## Safety Notice – powerCON TRUE 1

Date: 4<sup>th</sup> July 2018  
Author: Thomas Walker  
Product: Tessera XD

# powerCON TRUE1

## Product Change Notification

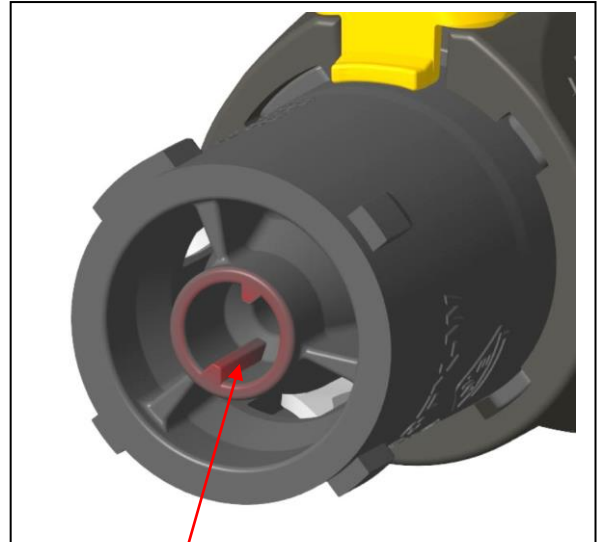
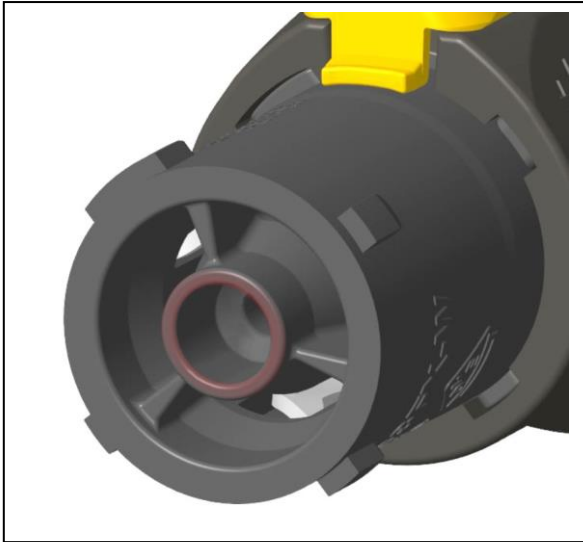
Modification on appliance inlet NAC3MPX:

Enlargement of center stopper

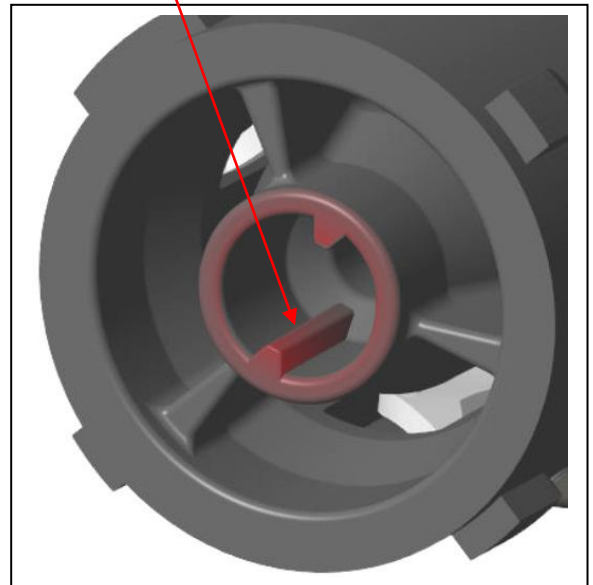
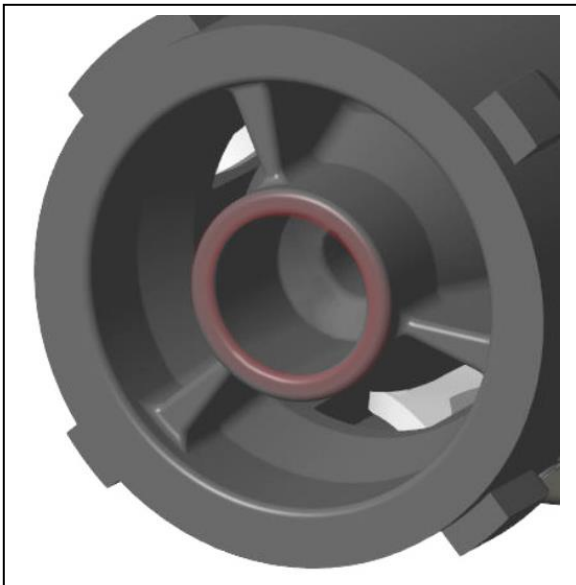
Modification on cable connector NAC3FX-W:

additional ribs

Correct insertion:

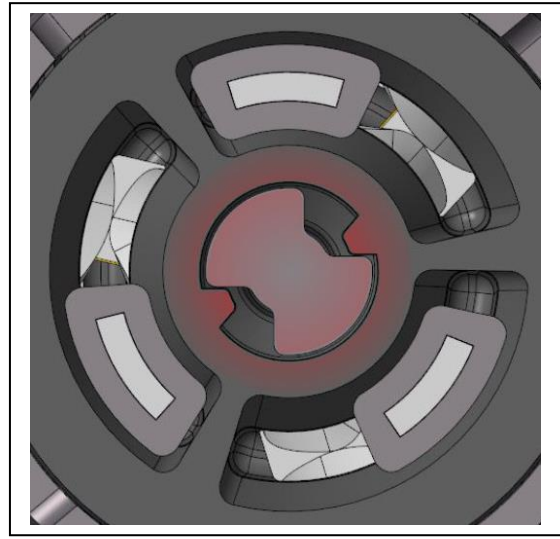
In the case of wrong insertion the additional ribs run up the stopper and prevent full insertion thus contacting is avoided.

Wrong insertion by 90°:

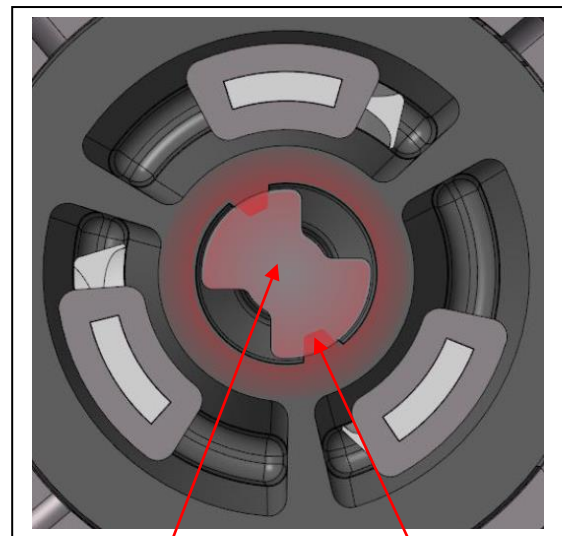
center stopper does block insertion by the ribs
